STAFF REPORT AND RECOMMENDATION TO THE DESIGN COMMISSION

CASE FILE: LU 13-147922 DZM AD – Janey II Apartments
Pre-App.: EA 12-173395 PC
REVIEW BY: Design Commission
WHEN: Thursday July 18, 2013 @ 1:30 PM
WHERE: 1900 SW Fourth Ave., Room 2500A
Portland, OR 97201

Proposal: The applicant has proposed the development of a new nine-story mixed-use building, to be known as the Janey II. The proposal is for a quarter-block site at the northwest corner of the intersection of NW 11th Avenue and Everett Street, directly east of the recently-completed quarter-block Janey Apartments. An existing one-story 1906 warehouse building on the site will be demolished.

GROUND LEVEL FLOOR PLAN

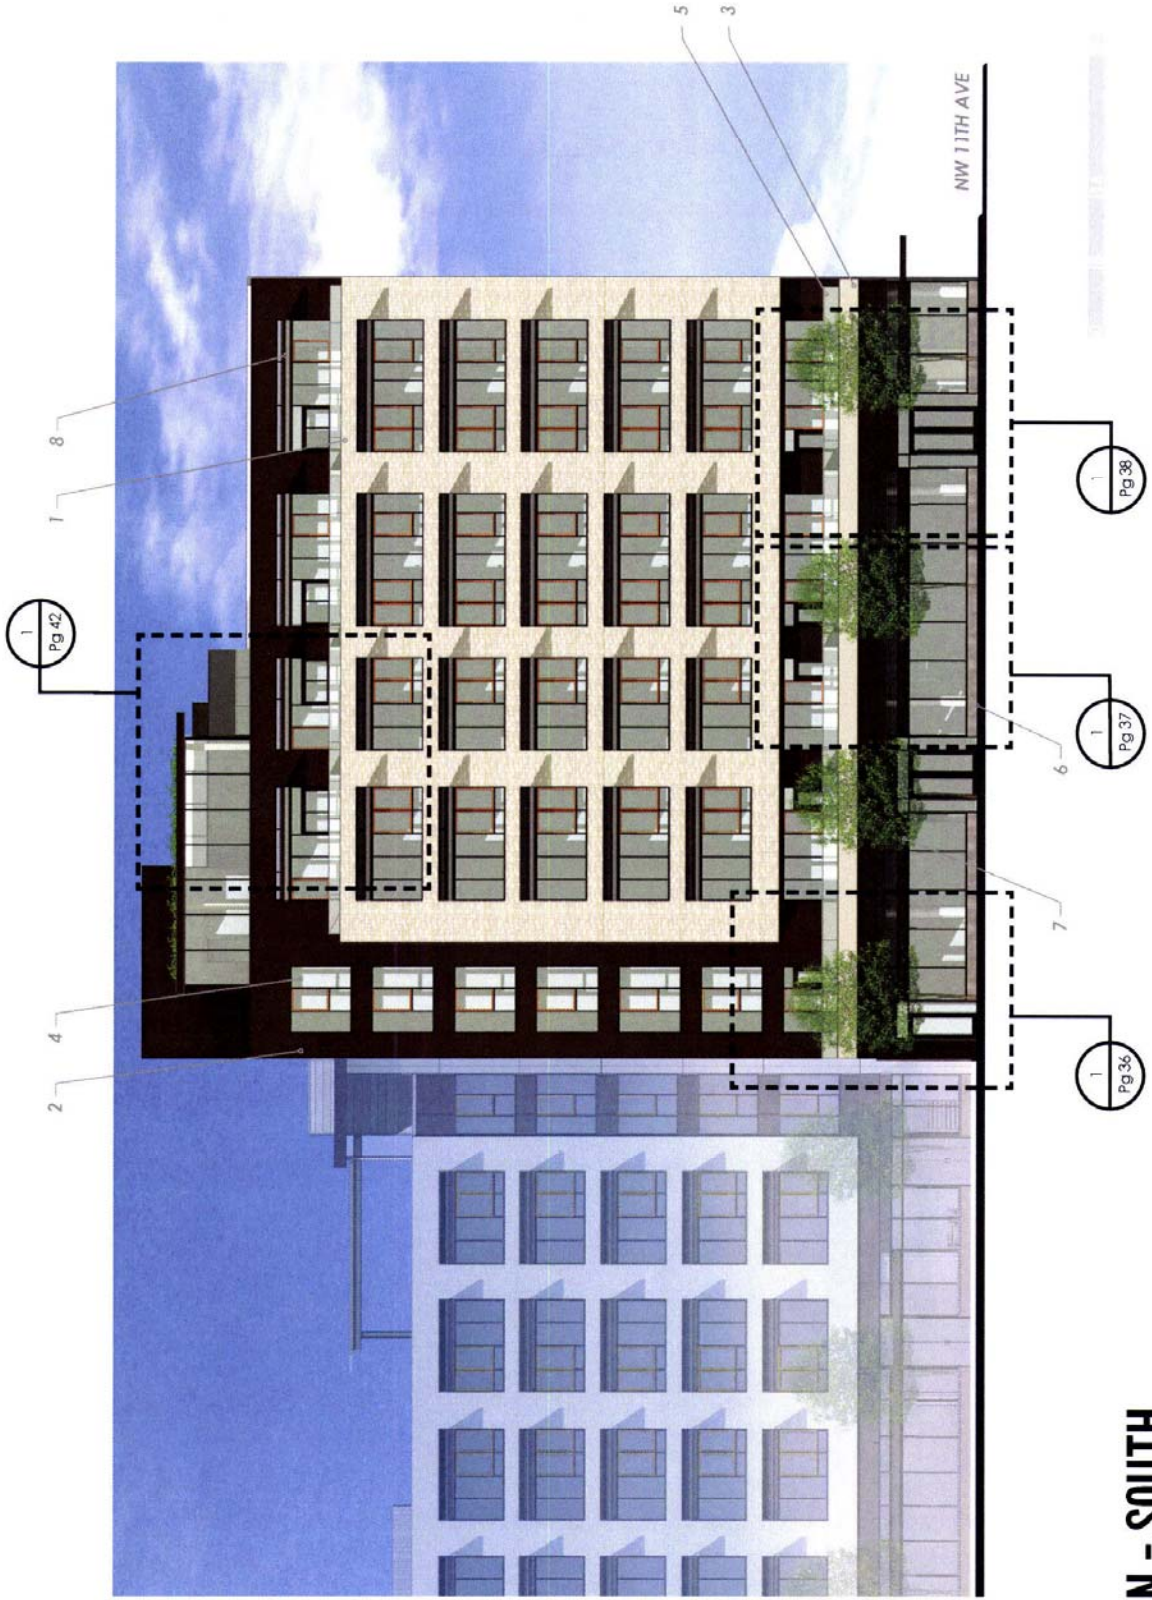
Along NW 11th Avenue, the first 44' of the building from Everett also includes the continuous canopy, with large glazed areas allowing views into the corner retail space. Beyond the retail space a section of glazing allows for views into a fire egress stairway, although the exterior window and canopy sequence remains the same. Further to the north on this façade, however, there is an inset egress door vestibule serving the garage, a single glazed opening that is rendered alternately as glass or as an art/retail display window, the metal mesh coiling loading door with metal louvers above, and another vertical opening in the brick skin for a large louver with a metal panel opening directly below.

This area of the street-level on the project does not support the pedestrian environment as successfully as it could, especially considering the adjacent streetcar stop. The expanse of wall adjacent to the interior parking area presents a filtered view into the parking area through the mesh door material, and the size and placement of the other elements including the glazing/display window could be further refined. This portion of the building could be a good location for public art, or a green wall of the type installed at the original Janey project along NW 12th Avenue, or an otherwise re-designed façade that better engages the pedestrian environment.

Although the Everett Street face of the project meets these guidelines, the 11th Avenue side requires further consideration and design changes to provide human scale and interest along the street, and integrate the loading, parking, and egress stair functions in a manner that does not detract from the pedestrian environment. *Therefore, these guidelines are not fully met.*

The regulatory intent of these two regulations are similar, and both Modifications are triggered by identical components on the building, namely the 38'-long length of storefront glass facing NW 11th Avenue just north of Everett. If the retail space inside the buidling extended an additional 12' to the north, these Modifications would not be required.

Along NW 11th Avenue, the first 44' of the building from Everett includes a continuous canopy, with large glazed areas allowing views into the corner retail space. Beyond the retail space a section of glazing allows for views into a fire egress stairway, although the exterior window and canopy sequence remains the same. Further to the north on this façade, however, there is an inset egress door vestibule serving the garage, a single glazed opening that is rendered alternately as glass or as an art/retail display window, the metal mesh coiling loading door with metal louvers above, and another vertical opening in the brick skin for a large louver with a metal panel opening directly below.

This area of the street-level on the project does not support the pedestrian environment as successfully as it could, especially considering the adjacent streetcar stop. The expanse of wall adjacent to the interior parking area presents a filtered view into the parking area through the mesh door material, and the size and placement of the other elements including the glazing/display window could be further refined. This portion of the building could be a good location for public art, or a green wall of the type installed at the original Janey project along NW 12th Avenue, or an otherwise re-designed façade that better engages the pedestrian environment.

The 11th Avenue side requires further consideration and design changes to meet the regulatory intent of enhancing the pedestrian environment and creating interest and activity per the above purpose statements. As noted earlier in this

report, this area of the façade also does not meet guidelines B1-1, B2 and C3-1. Further consideration and design changes are necessary to integrate the loading, parking, and egress stair functions in a manner that does not detract from the pedestrian environment. *Therefore, these criteria are not met.*

#1 – Ground floor design of the building along NW 11th Avenue, and the pedestrian experience of the garage/loading/mechanical/service stair sequence in the portion of façade north of the retail space.
